Access Compliance Report

(Curb Ramps)

Intersection ID: 4014	Main Street: DAVIS_LAKE_PY	Cross Street: DOWNING_CREEK_DR	Location: W
ADA ID: D8818CB85AF8	Ramp Type: PerpDiag	Initial Pass/Fail: Fail	Overall Compliance: No
Severity Score: 22.5			
Codes/Mitigation Info/Possible Solution		Field Measurements/Component Compliance

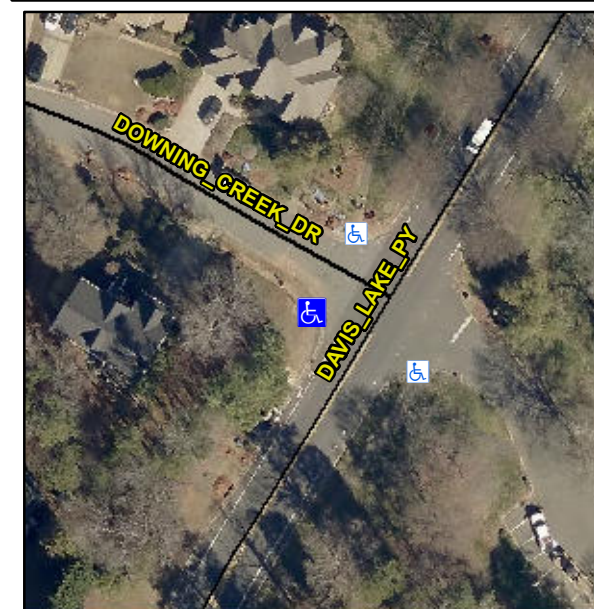
Not Found, R304.5.1, R304.2.2, R304.5.3

Compliance	Description	Data	Compliance	Description	Data
N/A	Ramp Length (in)	94.5	No	Ramp Slope (%)	10.2
No	Ramp Width (in)	37.0	No	Ramp XSlope (%)	3.3
N/A	Flare Type LT	N/A	N/A	Flare Type RT	N/A
N/A	Flare Slope LT (%)	N/A	N/A	Flare Slope RT (%)	N/A
N/A	Flare Traversable LT?	N/A	N/A	Flare Traversable RT?	N/A
N/A	Landing Length (in)	N/A	N/A	DWS Provided?	N/A
N/A	Landing Width (in)	N/A	N/A	DWS Contrast?	N/A
N/A	Landing Slope (%)	N/A	N/A	DWS Length (in)	N/A
N/A	Landing X Slope (%)	N/A	N/A	DWS Full Width?	N/A
N/A	Landing Curb? (Y/N)	N/A	N/A	DWS Offset (in)	N/A
N/A	Shared Landing?	N/A			
N/A	Gutter Ponding?	N/A	N/A	Gutter Slope (%)	N/A
N/A	Gutter Lip Ht (in)	N/A	N/A	Gutter X Slope (%)	N/A
N/A	Painted X Walk1?	No	N/A	Painted X Walk2?	No
	X Walk 1 Direction	To SE		X Walk 2 Direction	To NE
N/A	X Walk 1 Width (in)	N/A	N/A	X Walk 2 Width (in)	N/A
	X Walk 1 Slope (%)	4.9		X Walk 2 Slope (%)	4.7
	X Walk 1 X Slope (%)	7.4		X Walk 2 X Slope (%)	8.5

Remove & Replace Curb Ramp With Two New Directional Ramps or Equivalent.
